KEY ISSUES

- ▶ No development controls apply to land zoned R5 Large Lot Residential
- ▶ The Huntlee Development Control Plan enables further subdivision of lots proposed in the Stage 1 Application
- ▶ Riparian Areas - The subdivision pattern neglects to comply with *Water Management Act 2000* guidelines and condition C14. b)
- ▶ There are no requirements for traffic management infrastructure other than that required for Wine Country Drive
- ▶ The level of detail provided by the *State Environmental Planning Policy (Major Development)* and Huntlee Development Control Plan is very rudimentary
- ▶ Conditions E3 and E4 of the Department's recommended conditions pose great financial risk to Council
- ▶ Local Contributions - Council are currently in negotiation with the proponent regarding local contributions

STAGE 1 APPLICATION AREA WITH NO APPLICABLE DEVELOPMENT CONTROLS SHOWN SHADED

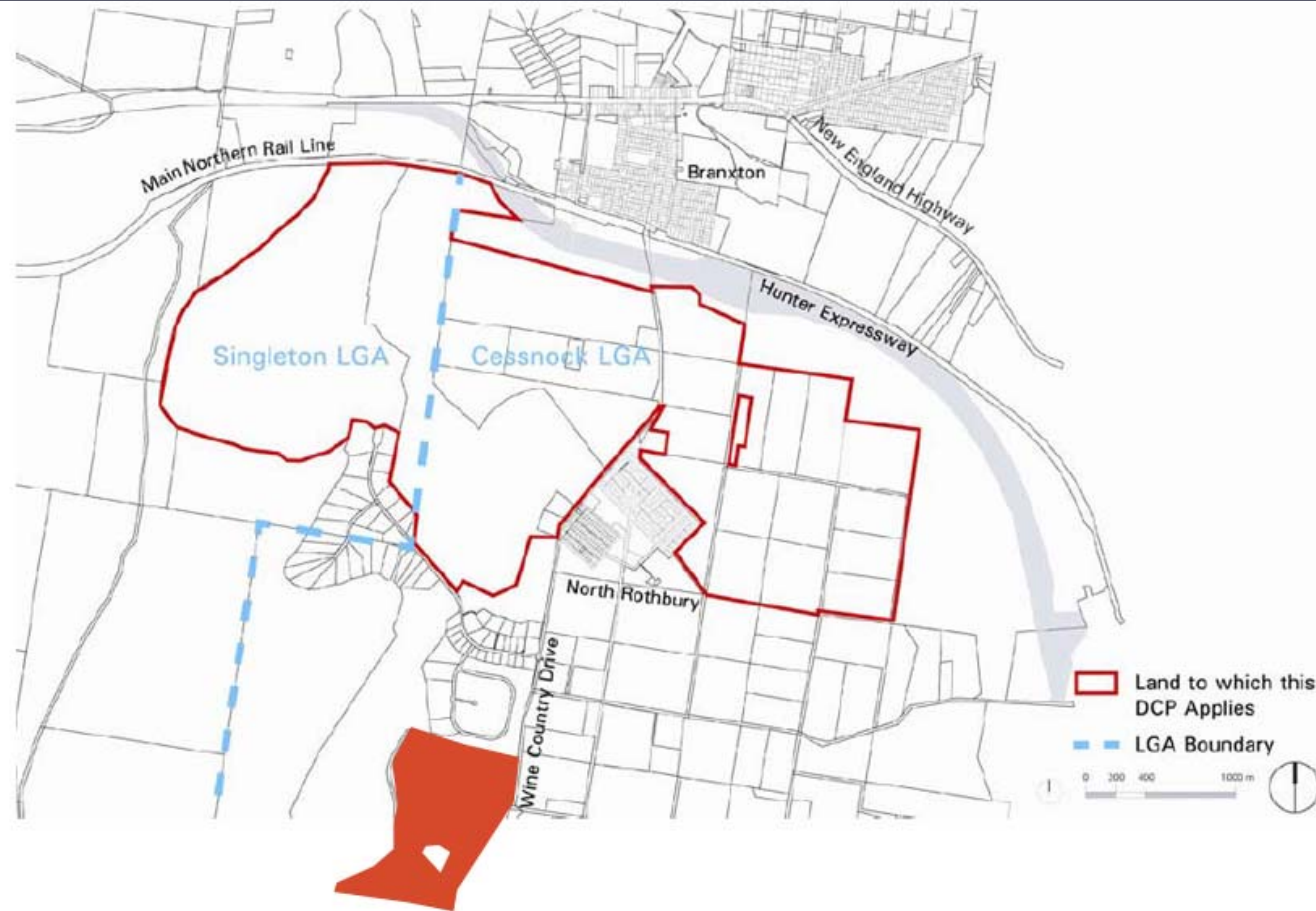
NO DEVELOPMENT CONTROLS

LOT YIELD

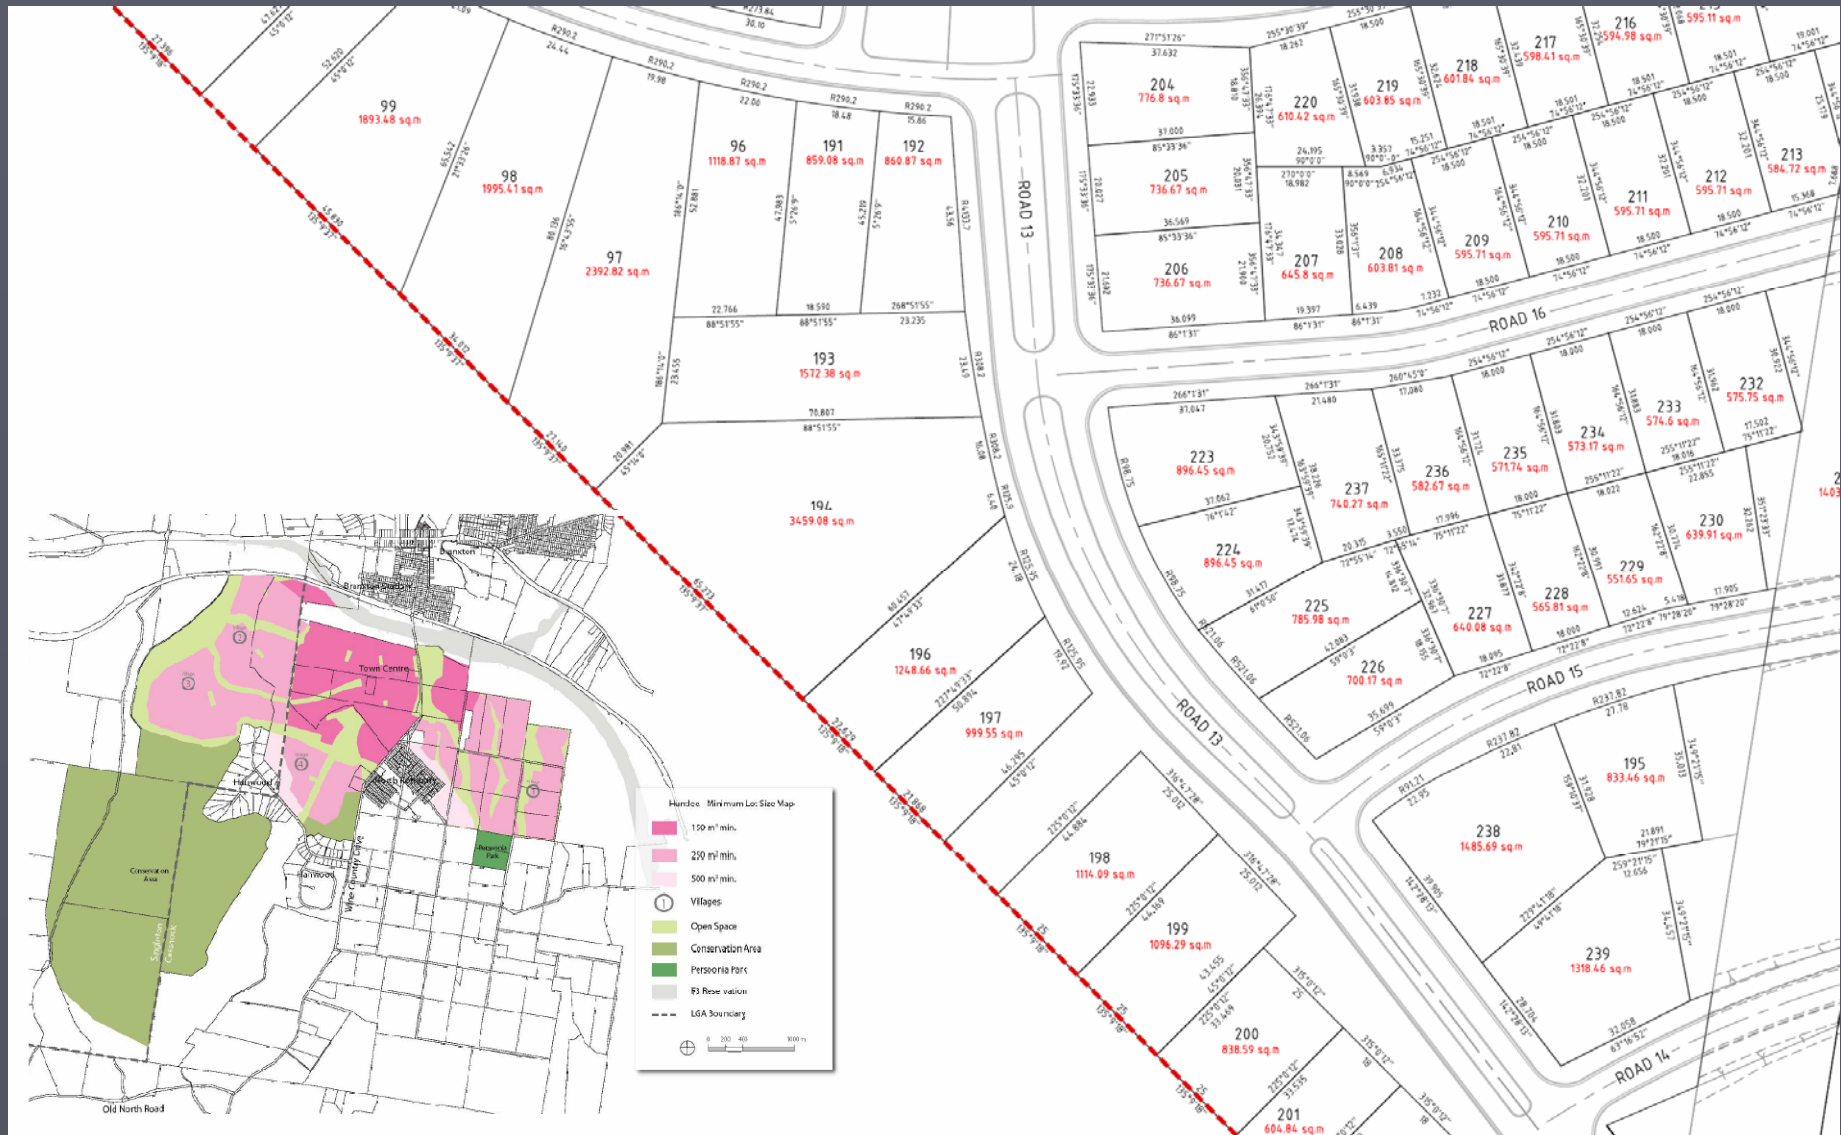
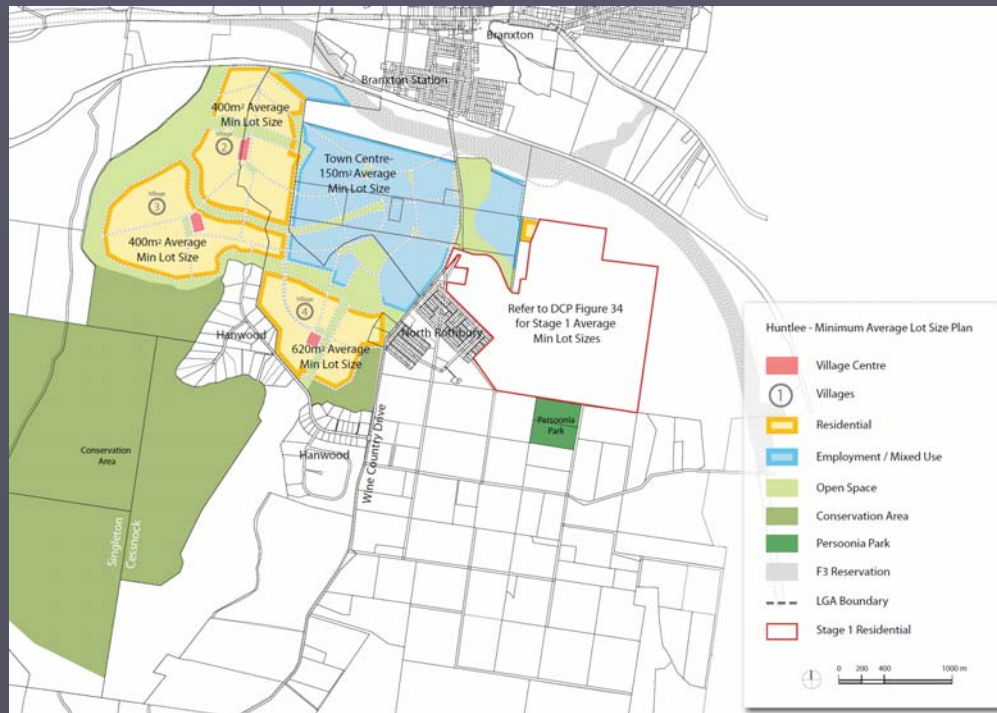
- ▶ Current status of negotiated amendments to the minimum lot size mapping control in the Huntlee Development Control Plan
- ▶ Negotiations are currently taking place between Cessnock City Council and the Huntlee New Town proponent

Stream Orders overlaid
onto proposed
subdivision

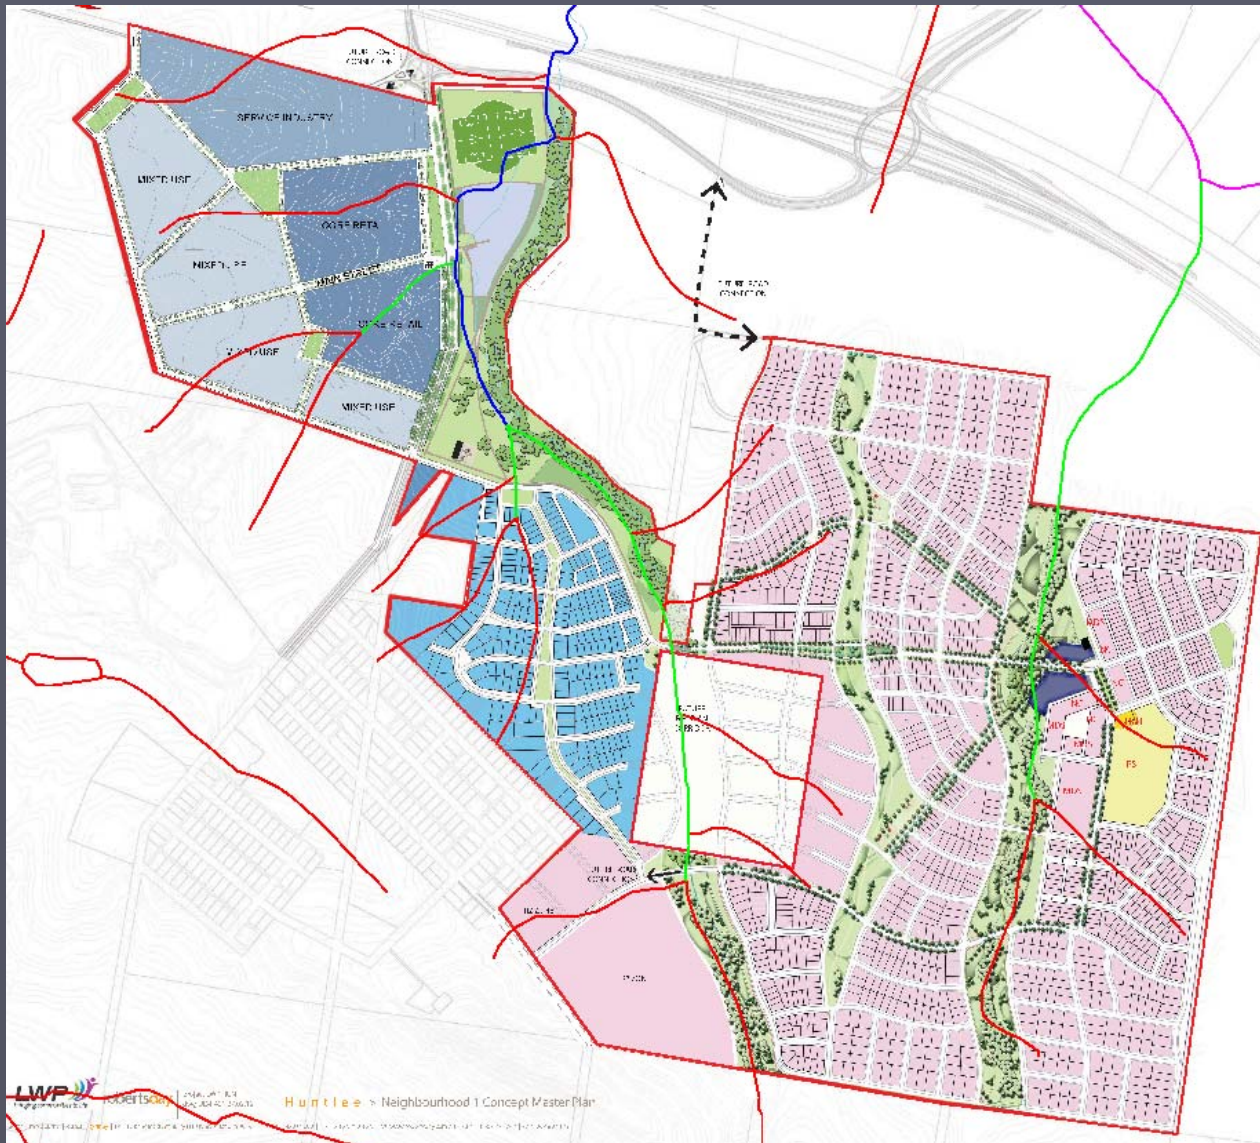
The subdivision pattern
neglects to accommodate
streams and their
associated Riparian
Corridors

Removal of first and second order streams are inconsistent with NSW Office of Water *Guidelines for Controlled Activities (July 2012)*

Figure 12: Indicative Layout and Staging Plan

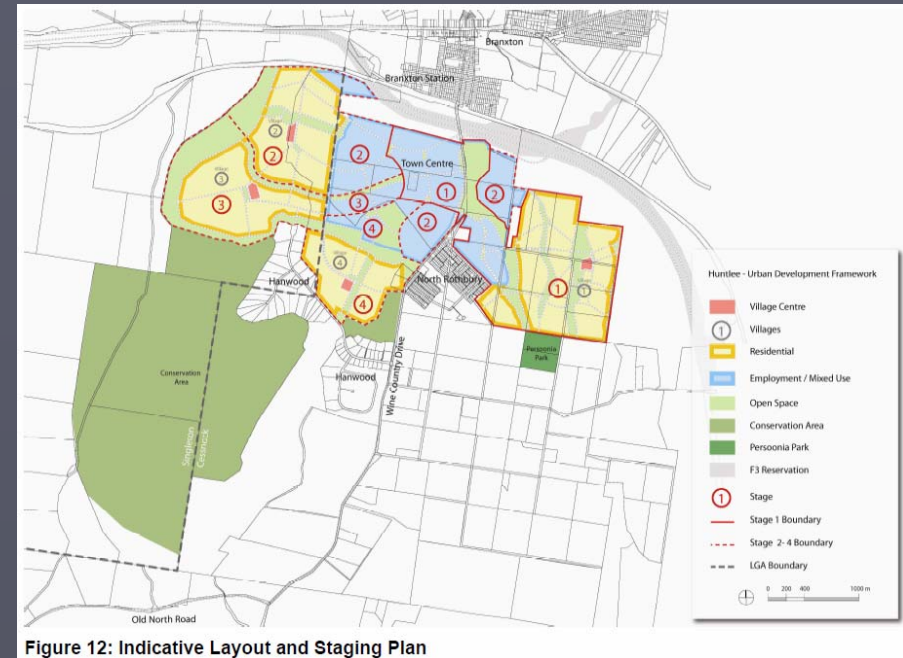
The Huntlee Indicative Layout Plan neglects to understand the complexity and layers associated with a town the scale of Huntlee. Details such as residential densities, the location of schools, the types of public land use (drainage, riparian, open space, etc) and the location of utility infrastructure is not provided.
